Submit 1 Copy To Appropriate District  State of New Mexico	Form C-103
District I – (575) 393-6161 Energy, Minerals and Natural Resources	Revised August 1, 2011 WELL API NO.
1625 N. French Dr., Hobbs, NM 88240 District II – (575) 748-1283	30-015-30702
811 S. First St., Artesia, NM 88210 \ \ OIL CONSERVATION DIVISION	5. Indicate Type of Lease
District III - (505) 334-6178 1000 Rio Brazos Rd., Aztec, NM 87410 1220 South St. Francis Dr. South Fo. NIM 87505	STATE X FEE
District IV – (505) 476-3460  1220 S. St. Francis Dr., Santa Fe, NM	6. State Oil & Gas Lease No. E-6353
87505 <b>MOTE</b> :	
SUNDRY NOTICES AND ŘEPORTS ON WELLS (DO NOT USE THIS FORM FOR PROPOSALS TO DRILL OR TO DEEPEN OR PLUG BACK TO A	7. Lease Name or Unit Agreement Name
DIFFERENT RESERVOIR. USE "APPLICATION FOR PERMIT" (FORM C-101) FOR SUCH PROPOSALS.)	CONOCO 8 STATE COM

Well: Conoco 8 State Com #1

## CONDITIONS OF APPROVAL FOR PLUGGING & ABANDONMENT

Operator: 000	
Well Name & Number: Conoco 8 State Com	#/
API#: 30-015-30702

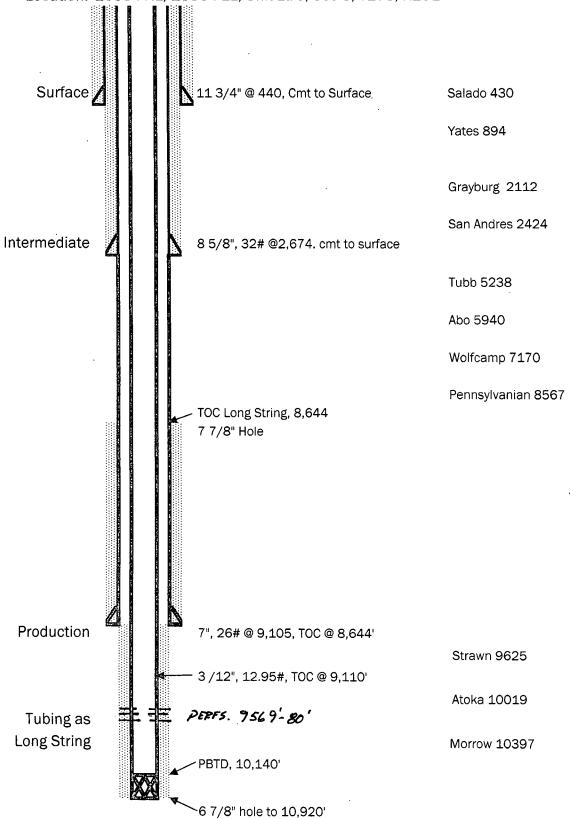
API: 30-015-30702 Elev: 3,611' GL Location: 1650 'N': 1550 FEL, Unit Ltr J, Sec 8, T17S, R29E -01Rc. 25 SXS.CMF. @13'-3! Surface / 11 3/4" @ 440, Cmt to Surface - Pump 45 5x6.cm7 ( 490 - 380' - MG - Pump 45 5x5. cmr. @ 944'-844'- MG - Pump 55 5x5.cmf.CD 27341-26141-TAG Intermediate 8 5/8", 32# @2,674. cmt to surface -CUT X PULL 7" est. @ 2674' PXA. RUM PERF X 598. 60 SXS. CMT. C. 6020'-5860! 5 PERF. X SQ 2. 70 5x5. cm7. ( 7255'- 7085'-146. TOC Long String, 8,644 7 7/8" Hole PXA MUD Pump 35 5x5. cmiCP. 9200'-9010'-TAG 5 CUT X PULL 3 1/2" 7B6-CD 9185' Production 7", 26# @ 9,105, TOC @ 8,644' 3/12", 12.95#, TOC @ 9,110' — DUMD BASL 35'CMT.C" 9325'-9490! 3 1/2" CD3P@ 95251 Tubing as PERFS. 9569 - 80' Long String PBTD, 10,140' 6 7/8" hole to 10,920'
